# Collector Wind Farm LVIA Addendum A

Response to Clouston Associates Peer Review S13-0011  
(Dated 10 May 2013)

**Project:** Collector Wind Farm

**Report Title:** Collector Wind Farm Addendum

Figure 1  
Distance effect

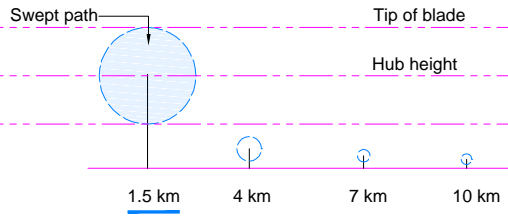
Aspects and issues identified within the Clouston Associates Peer Review	GBD Response	Addendum A reference
<ul style="list-style-type: none"> <li>Inherent shortcomings in treating the whole of Collector Village as one viewer</li> </ul>	<p>An additional assessment of residential and public view locations within Collector Village has been undertaken and is presented in Addendum A.</p>	<p>Refer Figure 5 and Section 8 of Addendum A</p>
<ul style="list-style-type: none"> <li>Apparent understatement of the inherent visibility at distance of the ridgeline location of the turbines and overstatement of reduced ZVI implication of viewing lesser parts of any given turbine.</li> </ul>	<p>It is not apparent that there is an understatement of visibility at distance or overstatement of reduced ZVI implication of viewing lesser parts of any given turbine.</p> <p>Issues relating to visibility and the significance that distance can have on the overall magnitude of impacts are outlined in the original LVIA and included in Addendum A.</p> <p>An additional figure has been included to illustrate the potential for distance effect upon potential visual magnitude.</p>	<p>Refer Figure 1 and Section 7 of Addendum A</p>

Figure 2  
Landscape Character  
Areas

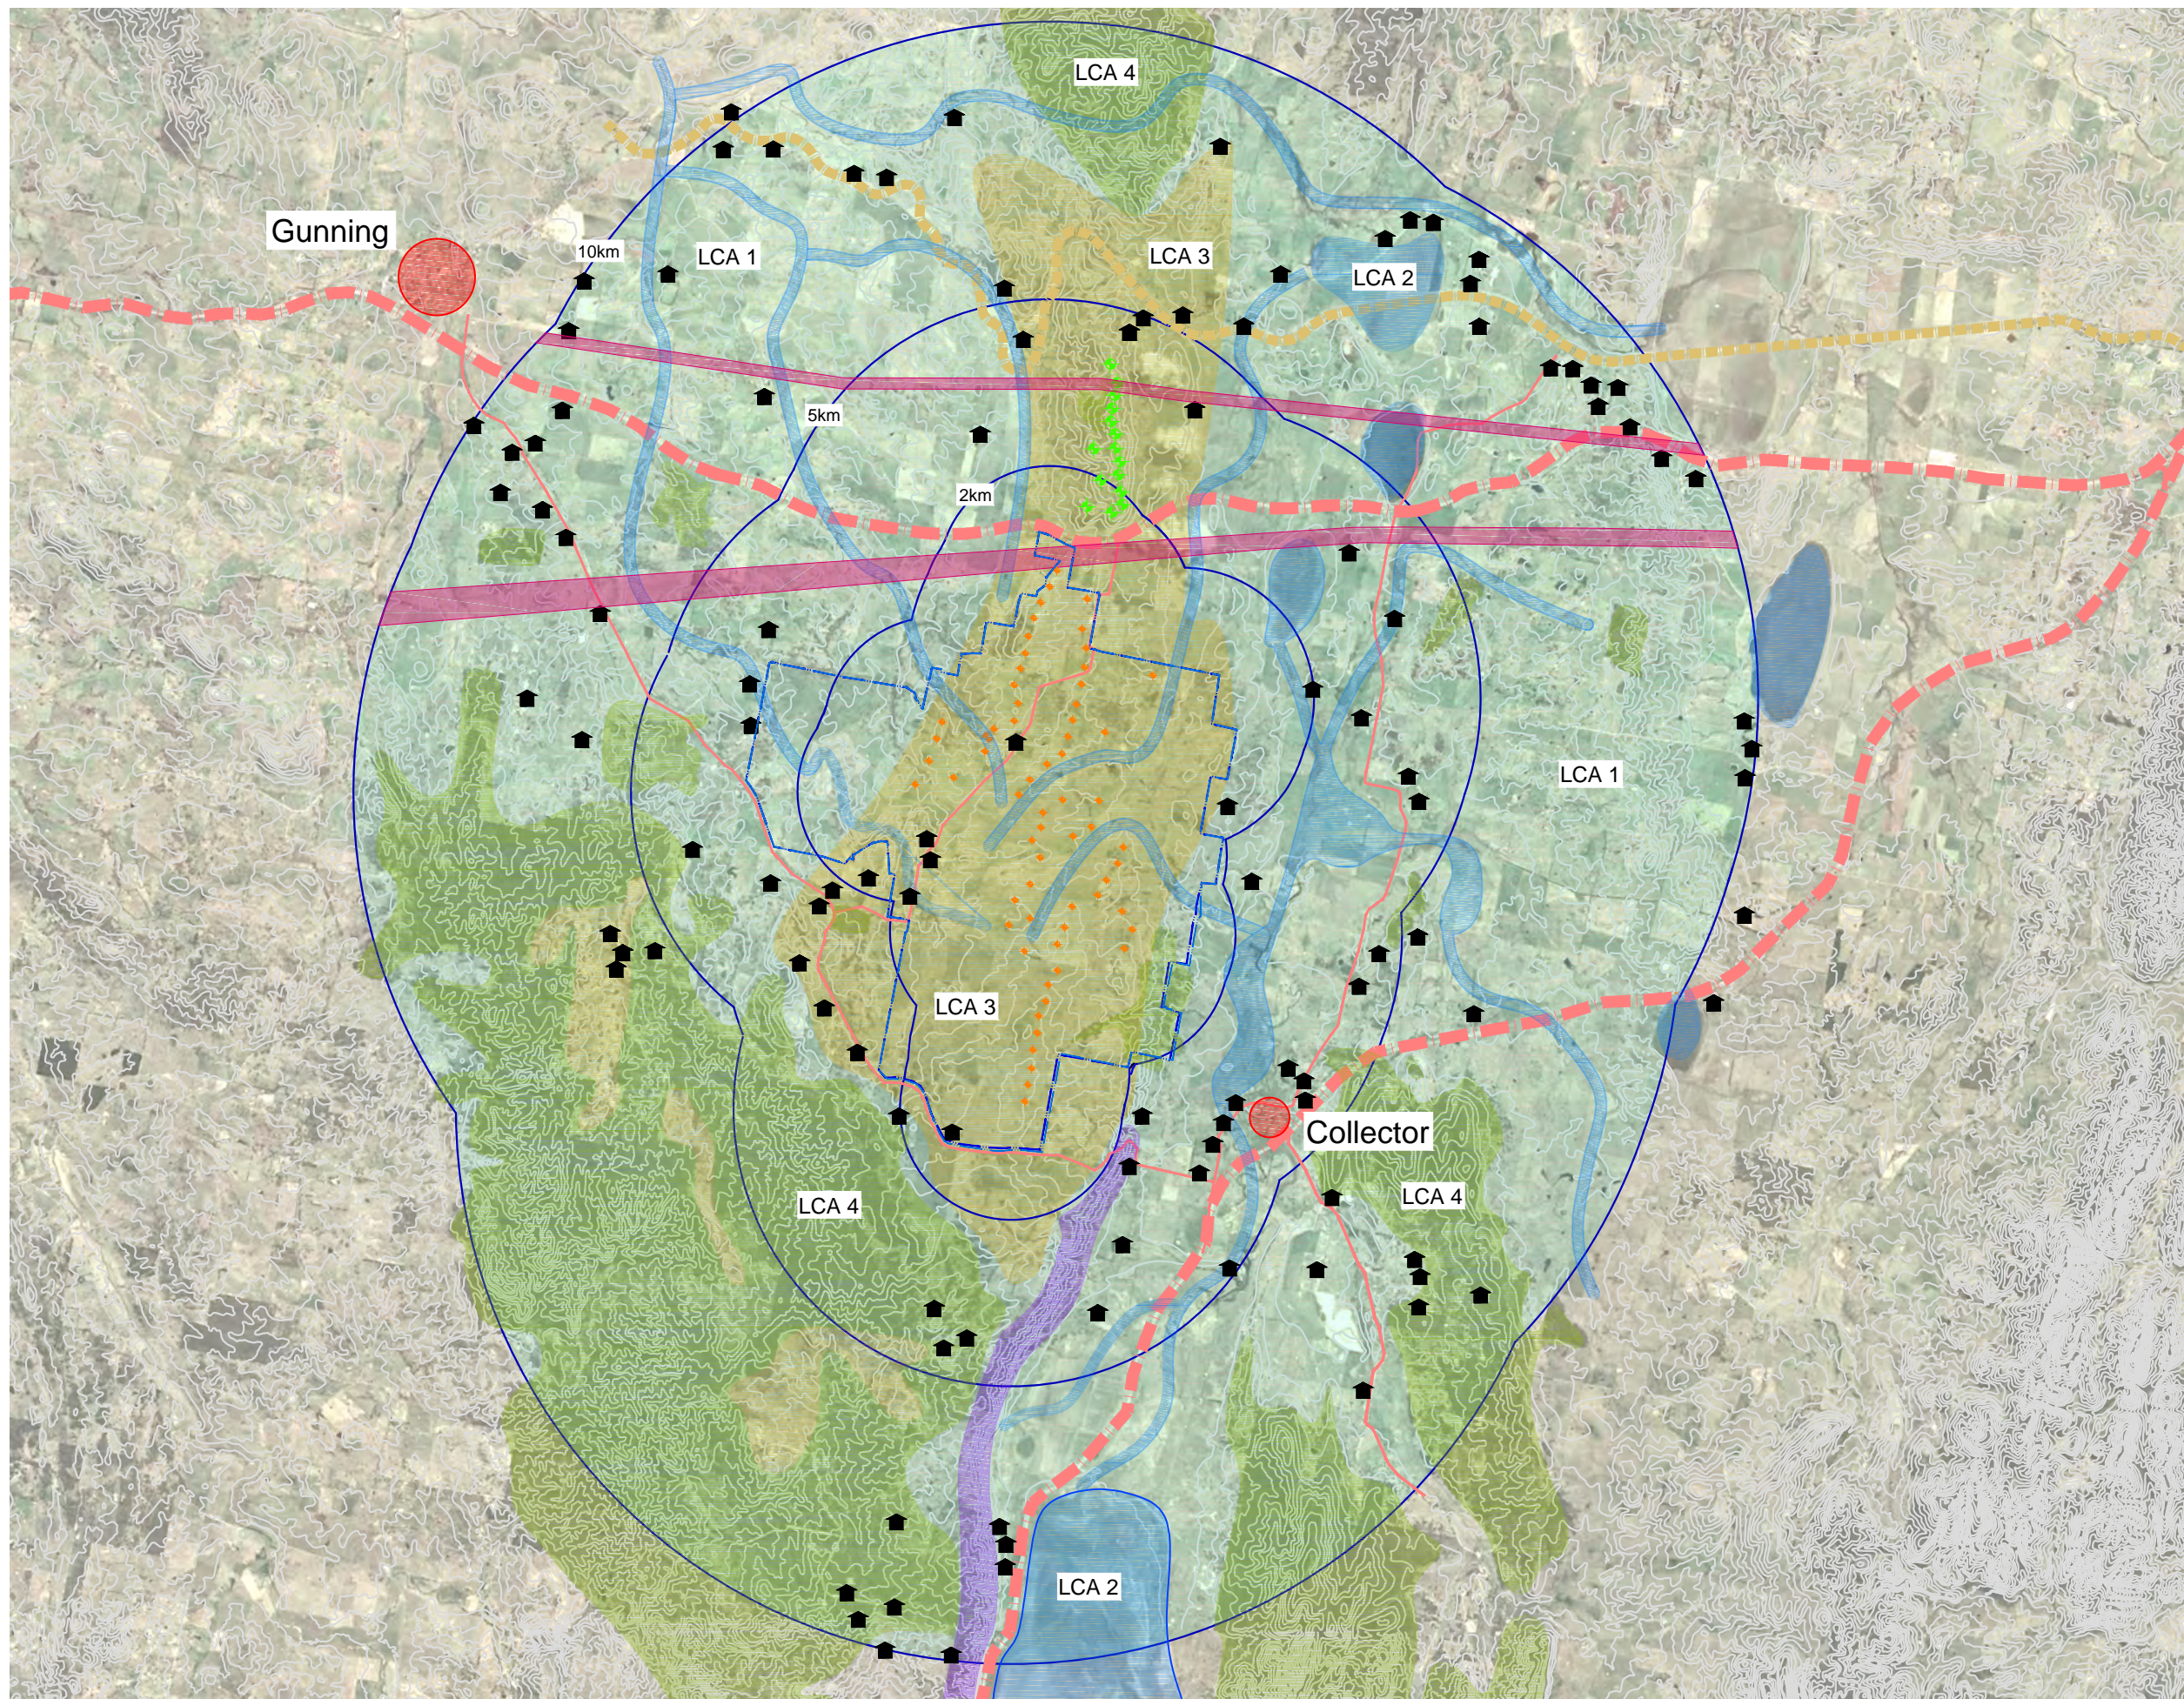
Aspects and issues identified within the Clouston Associates Peer Review	GBD Response	Addendum A reference
<b>Landscape Character and Sensitivity</b>		
<ul style="list-style-type: none"> <li>Shortcomings in the Landscape Character and Sensitivity evaluation, particularly in the basis of the LCA's, absence of mapping and lack of integration of community survey outcomes in establishing values and sensitivity</li> </ul>	<p>An additional figure that maps and illustrates the location and extent of the five LCAs identified in the exhibited LVIA has been included in Addendum A.</p> <p>Community survey outcomes have also been incorporated into a section describing existing landscape values within Addendum A.</p>	Refer Figure 2 and Section 6 of Addendum A
<ul style="list-style-type: none"> <li>The need for a more substantive overview of the landuse controls to assist in establishing a baseline for the assessment</li> </ul>	<p>Landuse controls and the permissibility of the proposed development are considered in detail within Section 3 of the EA; however, additional information relating landuse controls is provided within Addendum A.</p> <p>An additional consideration of the Draft NSW Planning Guidelines for Wind Farms has also been included within Addendum A.</p>	Refer Section 1 of Addendum A

Figure 6 - Transport corridors

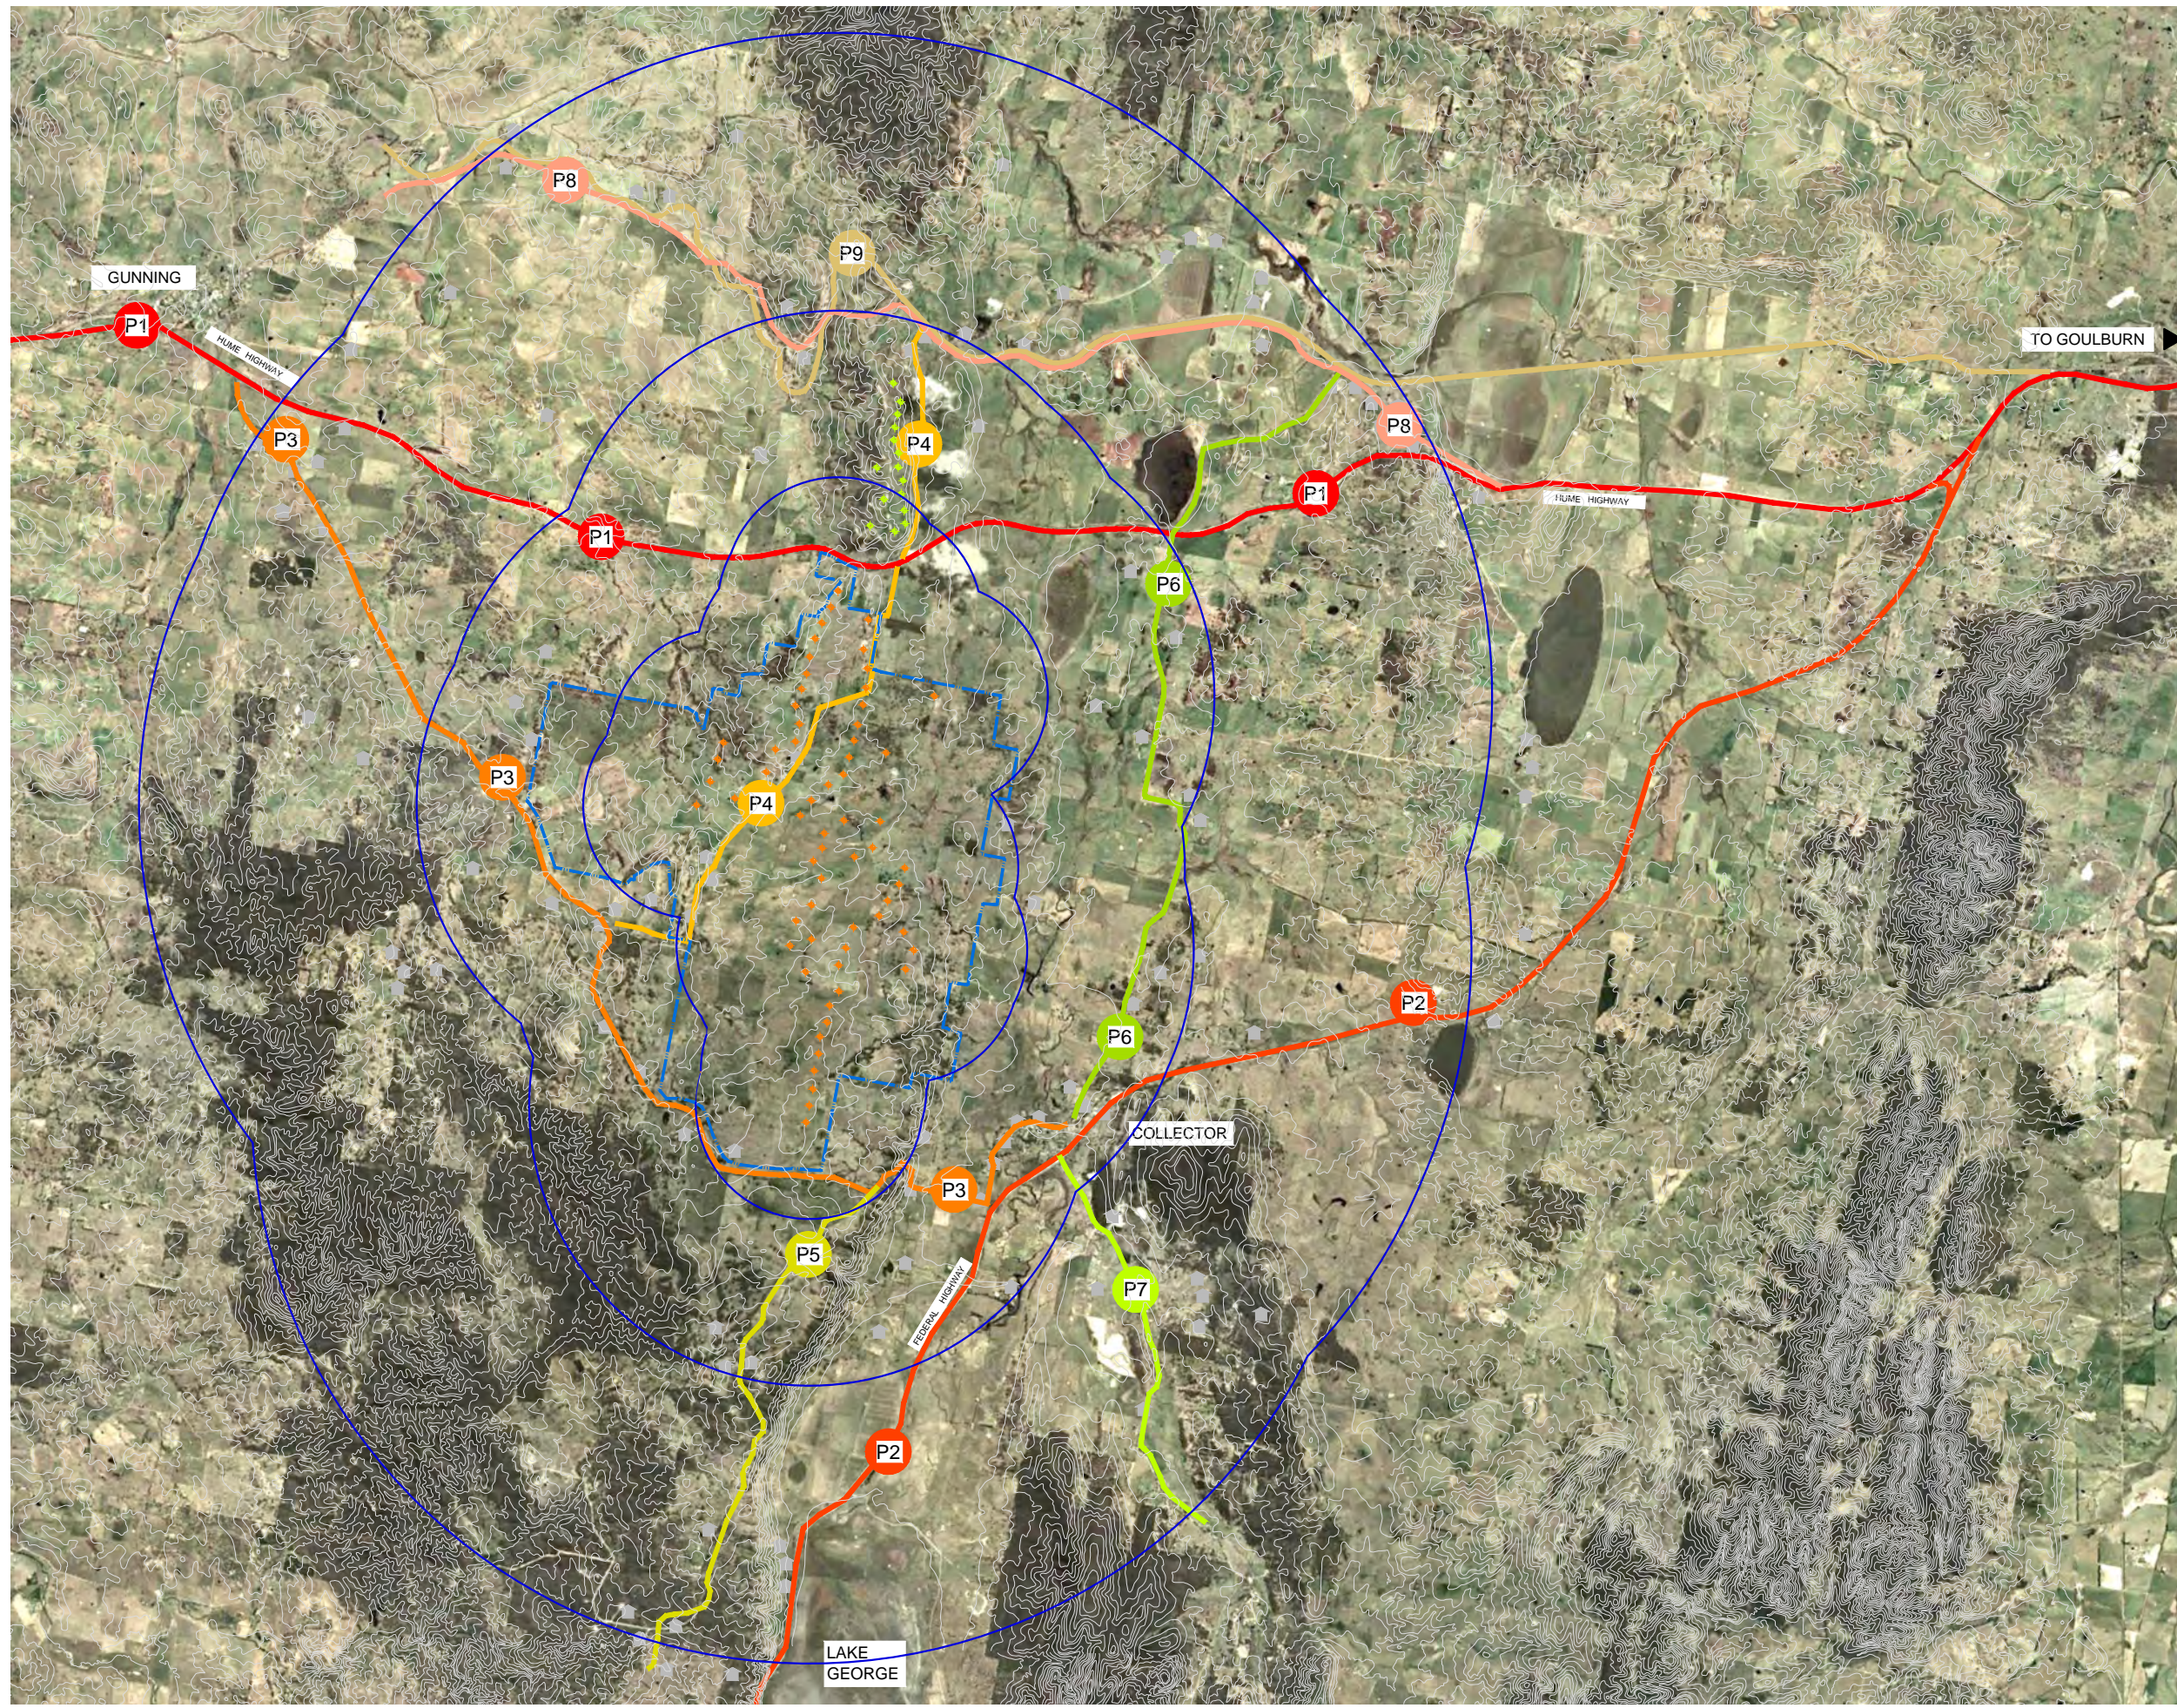
<ul style="list-style-type: none"> <li>Insufficient assessment of the visual impacts on cultural heritage features in the landscape.</li> </ul>	An assessment of cultural heritage features has been undertaken and presented in Addendum A.	Refer Figure 5 and Section 8 of Addendum A
<b>Visual Impact</b>		
<ul style="list-style-type: none"> <li>Inadequate assessment of the public domain visual impacts</li> </ul>	An additional assessment of public domain visual impacts has been undertaken and presented in Addendum A.	Refer Figure 5 and Section 8 of Addendum A
